ENVIRONMENTAL REVIEW TEAM REPORT

The Grove

Tolland/Coventry,

Review Date: NOVEMBER 13, 1986

SOIL TYPE DESIGNATION

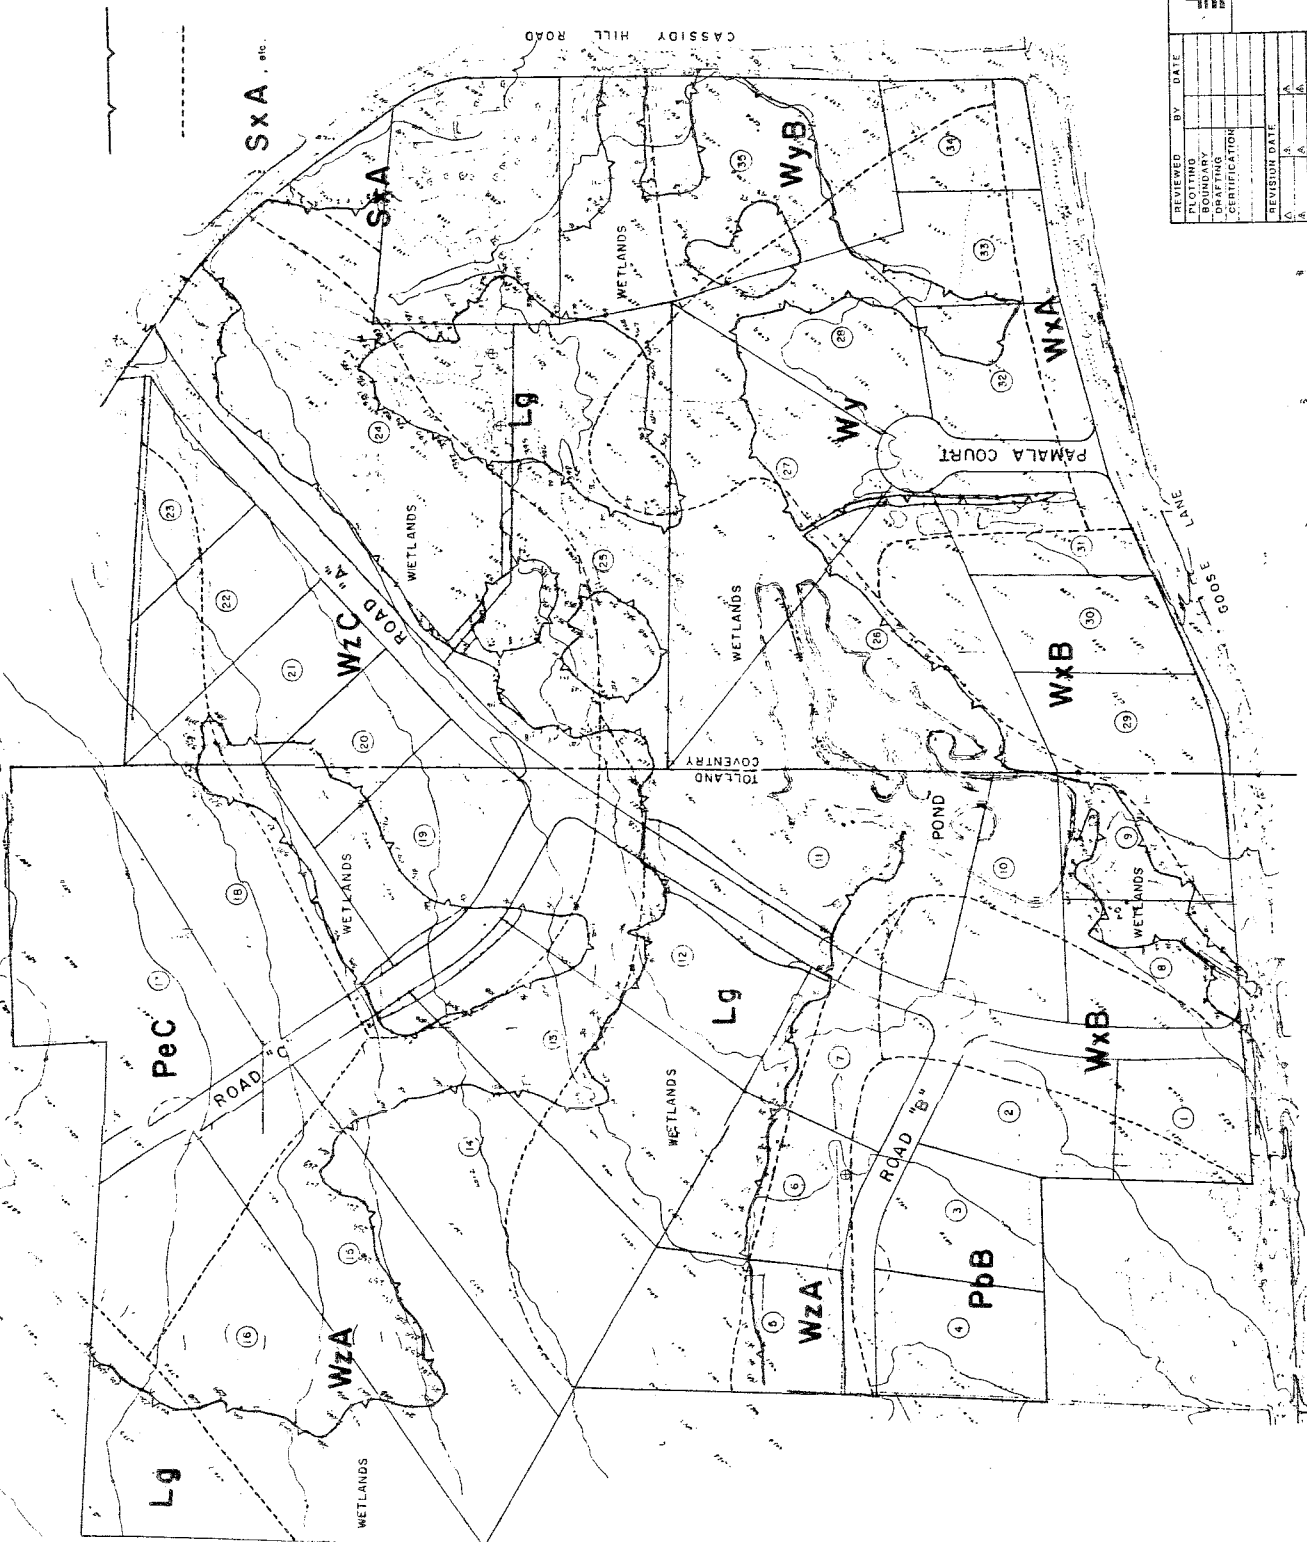
It was found that the wetlands on the site were substantially correct as flagged in the field. There is the possibility that a small parcel of wetlands exists to the east of stations 262 and 263. A watercourse may exist on Lot 12 between stations 304 and 285. These areas should be re-examined. The north edge of the pond on Lots 10 and 11 is also the wetland boundary and should be shown. The pond dike and outlet structure should be included within the wetland boundaries for all practical purposes as this structure is an integral part of the pond-wetland system. Watercourses within the wetlands should also be shown on the plan map. It appears that the ditch on Lots 36, 26 and 27 will be filled. If this is the proposal then a note to this effect should appear on the plan map. To avoid confusion it is suggested that the boundaries enlarged from the Soil Survey of Tolland County be removed from the 1" = 100' plan map. The information from the consultant soil scientist's high intensity survey and deep test pit report presents a much more accurate representation of actual field conditions on this site. If Soil Survey information is required, a copy of the survey map at a scale of 1" = 1,320' should be included separately.

Homesite locations on Lots 5, 6, 8, 9, 11, 12, 13, 14, 15, 20, 24, 26, 27, 32, and 35 place potential houses within fifty (50) feet of wetland boundaries. Five (5) lots (15, 20, 26, 27 and 32) have homes proposed closer than fifty feet (50'). Future lot owners may choose to alter the wetlands on their property which collectively can result in extensive alteration of wetlands on the parcel. The Wetland Commission should anticipate these activities and evaluate the collective impacts when considering this proposal. It is not known if any data exists on the extent to which lot owners alter wetlands on subdivided land. The DEP Wetlands Unit may have some information on this. In Tolland County several cases of extensive alterations of wetlands within subdivisions have been observed by the District.
